PROJECT: New Portland Service Building
Five (5) Foot East Truck Bay Building Addition
Punch List
Portland, Maine
DATE: Thursday, December 29, 2011

PUNCH LIST ITEMS

DRAWING: SECOND FLOOR & LOW ROOF FRAMING PLANS

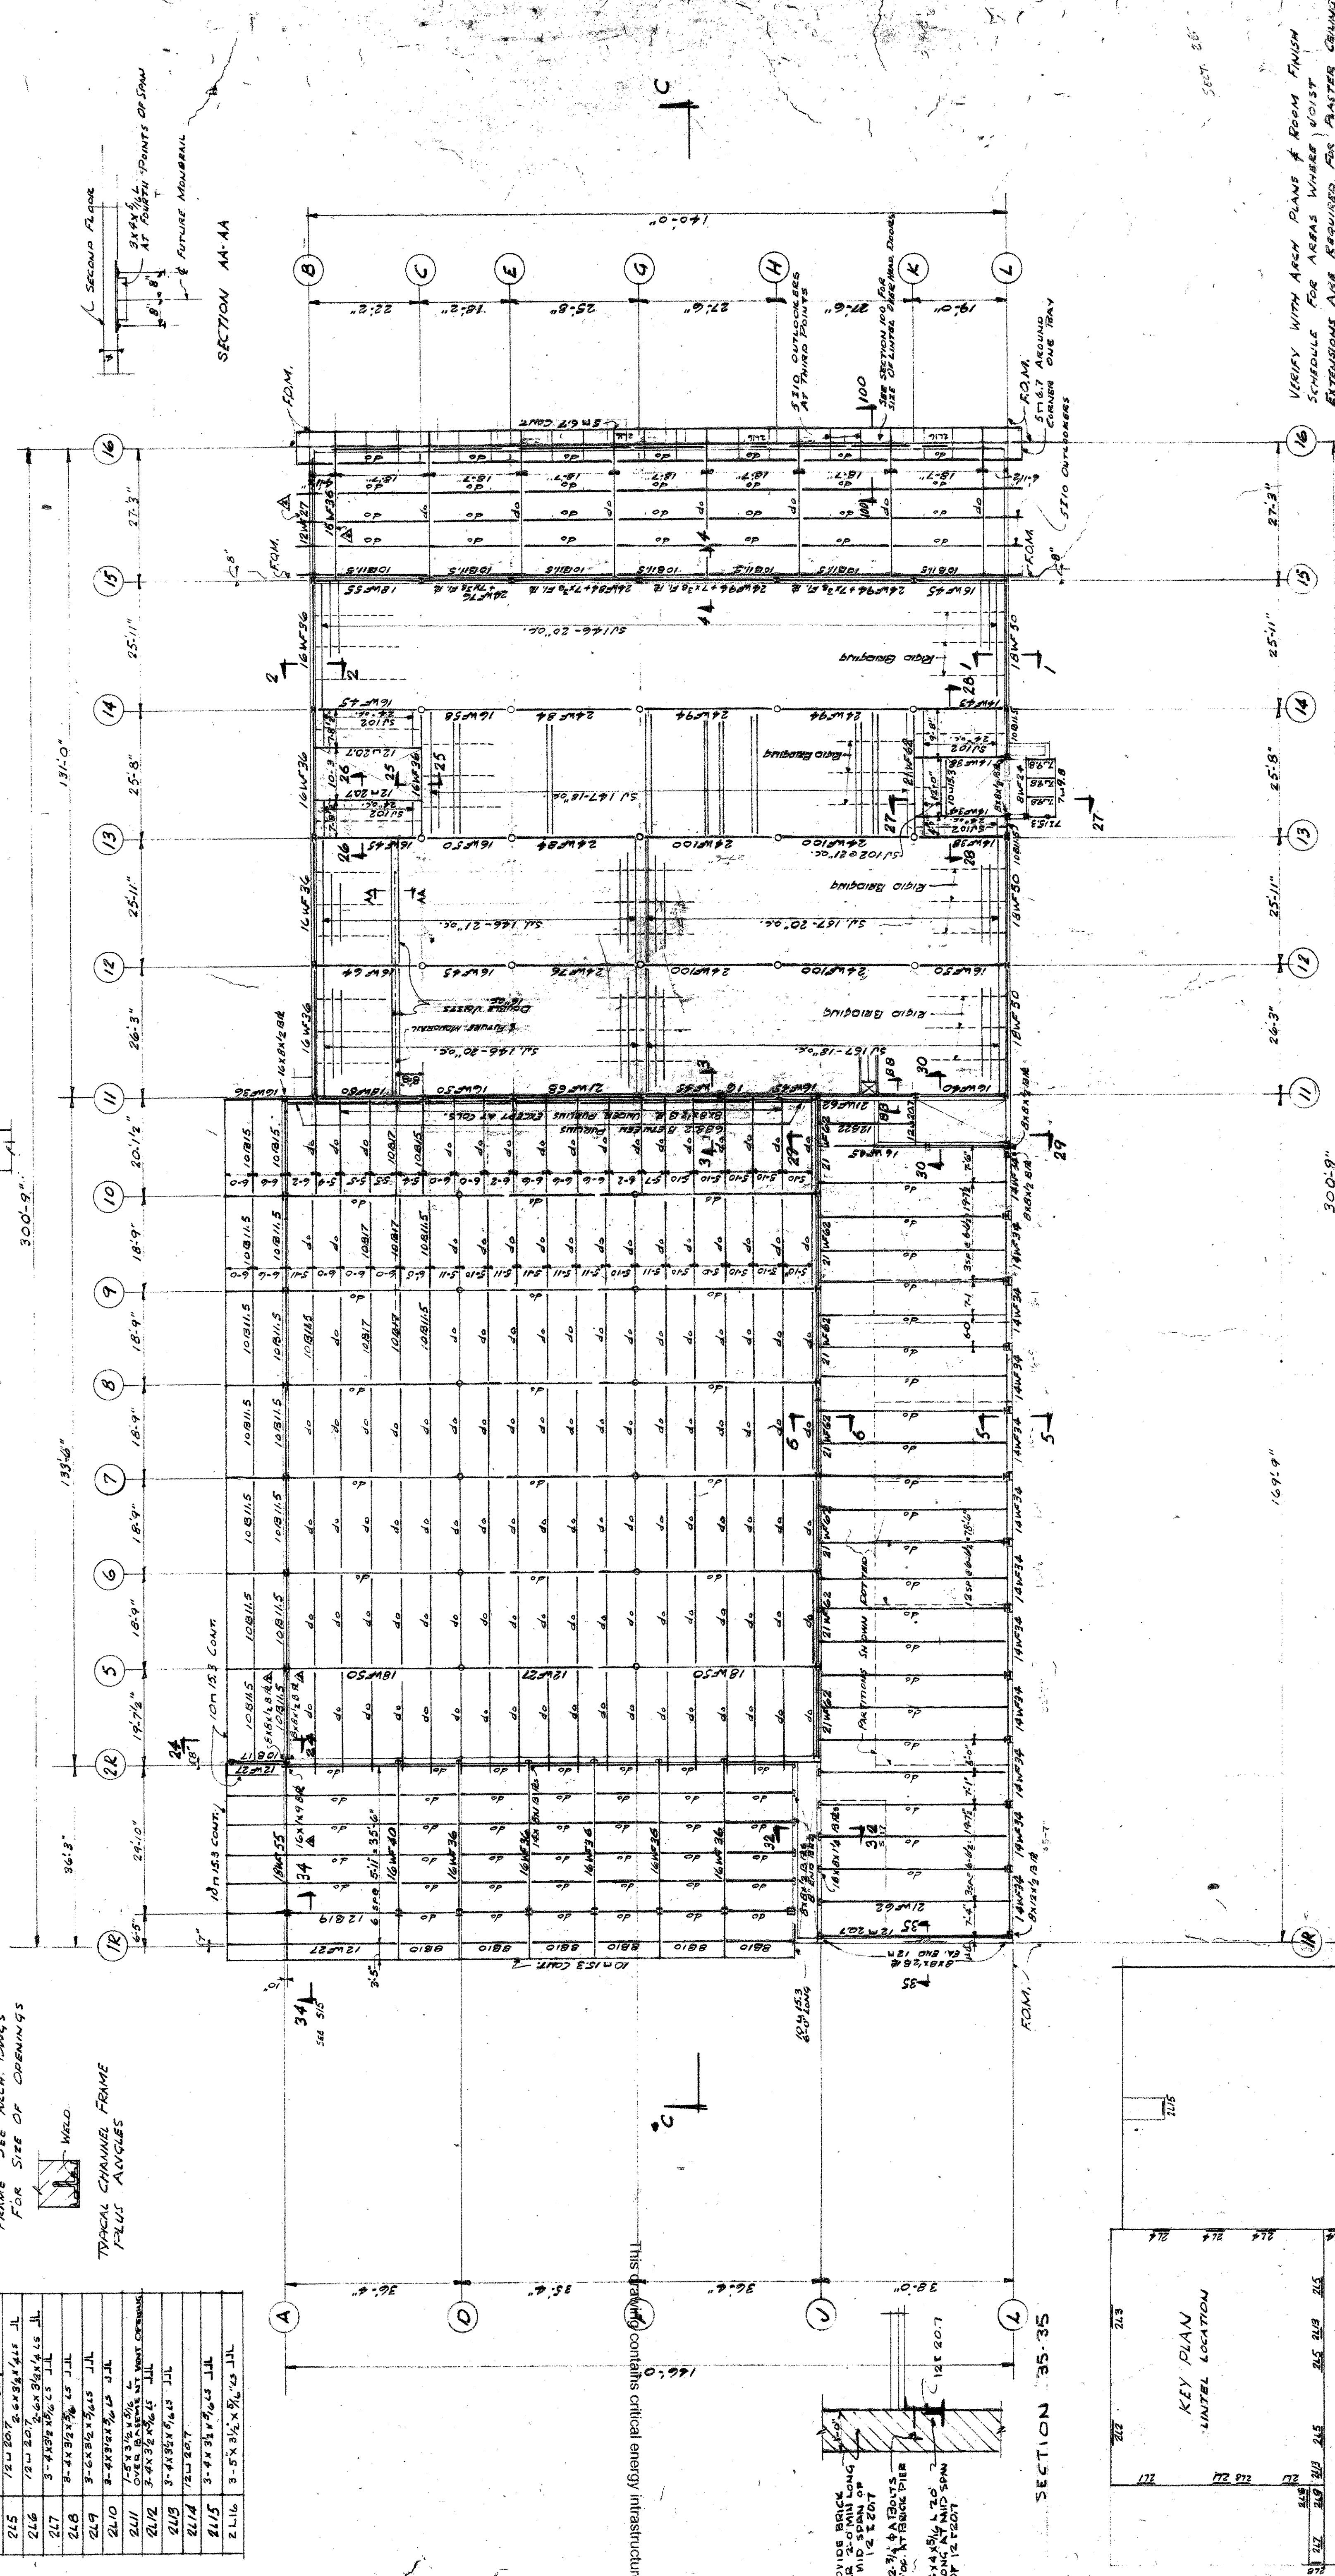
1. H.E. Callahan and Overhead Door Company have supported the door motors by extending partial angles from the door header beam back to the original door motor support that is fastened up to the second floor roof beams. There were no details on how to attach the new motors. Placing new motor supports 5 feet closer since the door moved 5 feet would have required tearing large holes in the ceilings to weld on brackets to the upper beams. This can still be done but would require that the holes be patched back in. Overhead Door felt the motor support extensions to the existing motor supports steel would adequately support the motor. It can safely support the weight of the motor; however, when the motor stops or is interrupted by the electric eyes and changes direction there is a high torque on the motor that creates the motor to significantly bounce and is not acceptable to CMP. H.E. Callahan will review the situation with Overhead Door and advisee CMOP and SECS. A copy of the second floor support steel drawing is attached in the event that the motor support needs to be extended to the floor beams.

NEW TRIM DETAIL @ EXISTING WINDOWS
SCALE: 3/8" = 1'-0"

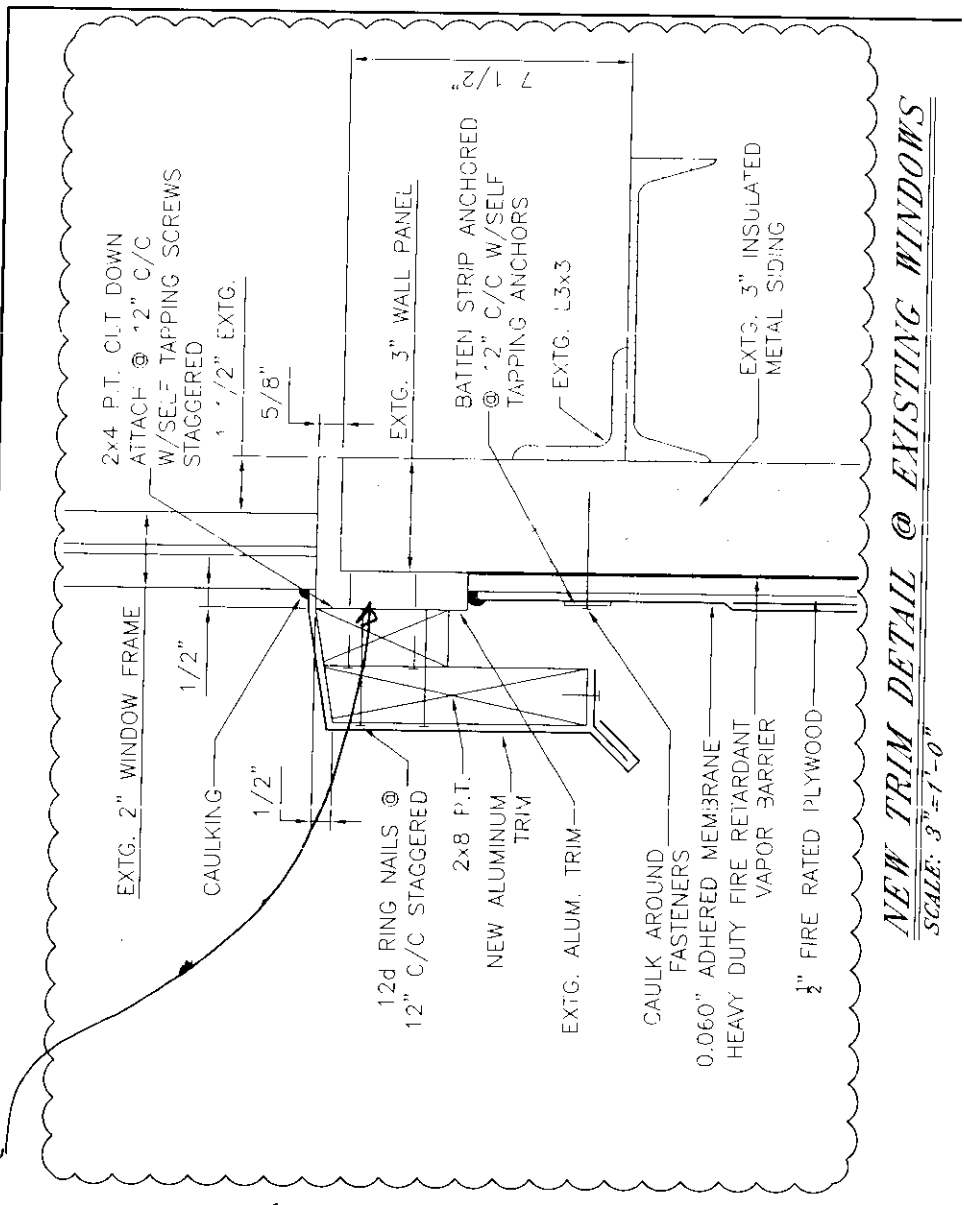
3. A leak was reported in the middle of overhead door #6. SECS's original design detail was changed by SMR roofers. The SMR detail is a good detail; however, it did not address the vertical seams that extend up onto the horizontal portion of the existing window sills. Also the existing window sills did not get recaulked as shown on the original detail. H.E. Callahan will need to get a detail to seal the open vertical/horizontal seams and recaulk the horizontal window seam. With the cold weather it may not be possible to do a permanent fix. SECS recommends as a minimum filling the open voids with RV sealant to get through the winter and prevent any damage to the new sheetrock. A copy of the original detail sketch is attached and photos showing the open vertical joints in the existing window trim.

Open joint in
vertical and top
horiz along window
trim

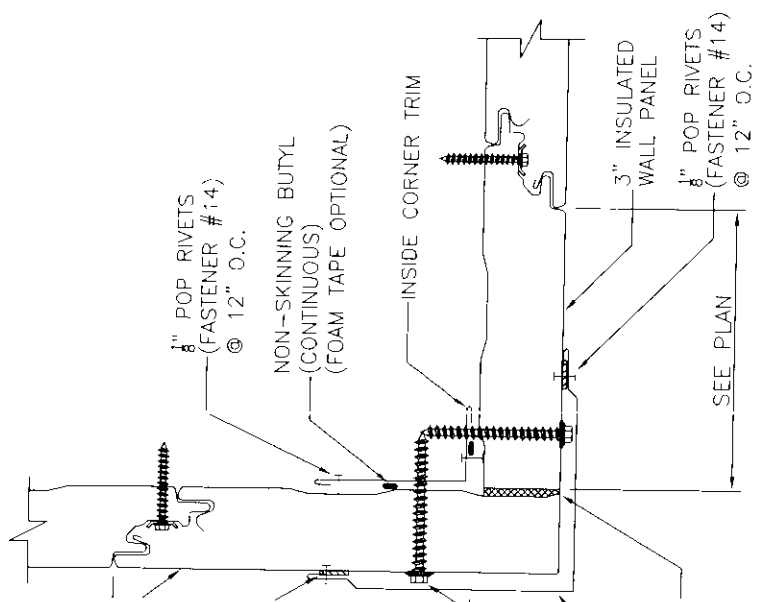
THE EXISTING WINDOW TRIM WHICH WAS EXTENDED HAS A VERTICAL GAP BETWEEN SECTIONS WHICH IS NOT SEALED
